Project	IEEE 802.16 Broadband Wireless Access Working Group < <u>http://ieee802.org/16</u> >
Title	Clarification of the OFDM DL Subchannelization Zone
Date Submitted	2005-03-08
Source(s)	Fraser CameronVoice: (403) 204-7765Wi-Lan Inc.Fax: (403) 273-51002891 Sunridge Way NEfcameron@wi-lan.comCalgary ABfcameron@wi-lan.com
Re:	Sponsor Ballot Comment
Abstract	This document proposes a clarification to the OFDM DL subchannelization zone
Purpose	For consideration as a modification to D6 during Sponsor Ballot resolution.
Notice	This document has been prepared to assist IEEE 802.16. It is offered as a basis for discussion and is not binding on the contributing individual(s) or organization(s). The material in this document is subject to change in form and content after further study. The contributor(s) reserve(s) the right to add, amend or withdraw material contained herein.
Release	The contributor grants a free, irrevocable license to the IEEE to incorporate material contained in this contribution, and any modifications thereof, in the creation of an IEEE Standards publication; to copyright in the IEEE's name any IEEE Standards publication even though it may include portions of this contrib

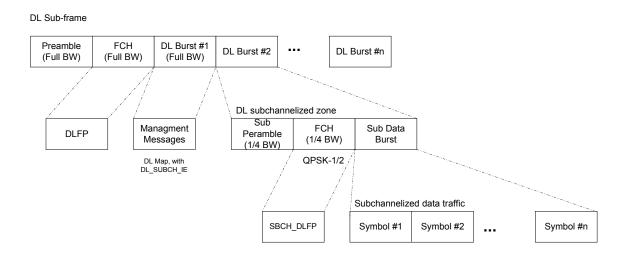
In section 8.3.5.1.1 of 802.16e/D6, the description of the DL subchannelization zone is not explicitly clear from the text how the structure of the subchannelized zone fits in with the DL sub-frame.

Figure 208a is also confusing, as it only shows the DL subchannelized portion of the sub frame and is not completely labeled. This looks similar to an OFDMA style of picture.

Replace figure 208a in section 8.3.5.1.1 with the following figure.
